Appellant's Exhibit 59

From: Vicki Orrico <Orrico@jmmlaw.com>
Sent: Wednesday, July 20, 2016 2:42 PM
To: Gary Lee
Cc: Sean Miller; Min Luo
Subject: RE: 16390 Cleveland St. Parcel number: 7198800085

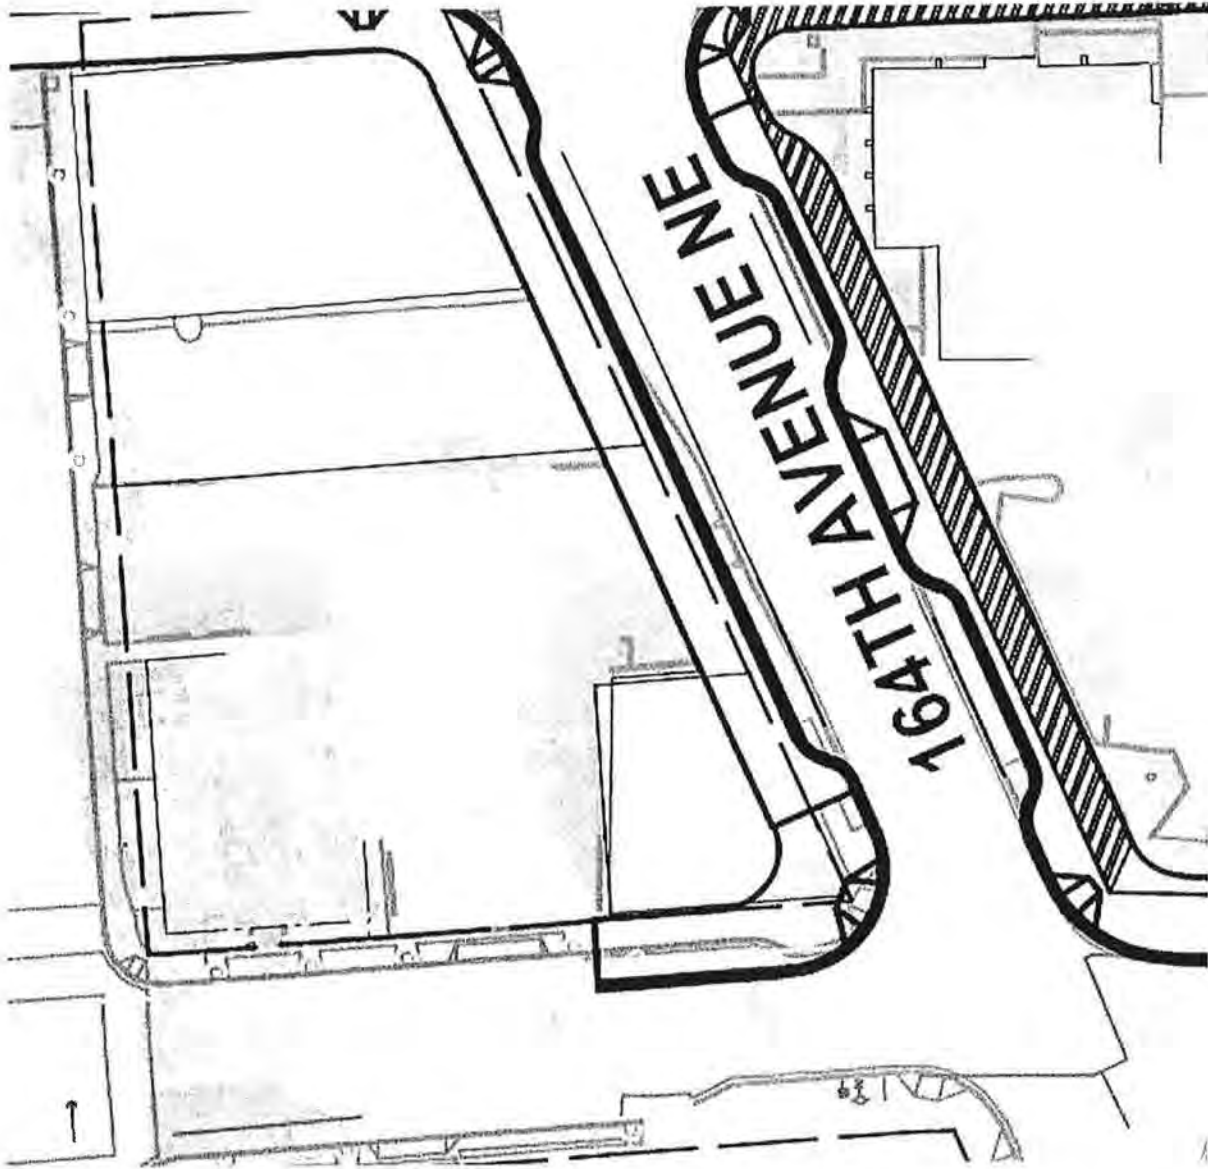
As mentioned by Min previously, you will need to do property frontage improvements, including new curb, gutter and sidewalk – according to City plans, if your improvements to the building equal or exceed the current assessed value of the improvements.

If the cost of the improvements to the building (with your project) equal or exceed \$23,500 (as assessed below) you will need to remove approximately 10' of the east side of the building (fronting 164th and the intersection) and build a new, wider, sidewalk as shown below. All of the costs associated with improving the building will be included.

Our general thinking is that you will be spending at least \$23,500 to make the building suitable for retail/commercial use, which will trip the requirement for the removal of the east side of the building and widening of the sidewalks. I think that this is very important for you to aware of.

Plans for this intersection call for the widening of the sidewalk as shown below. See arc through the building.
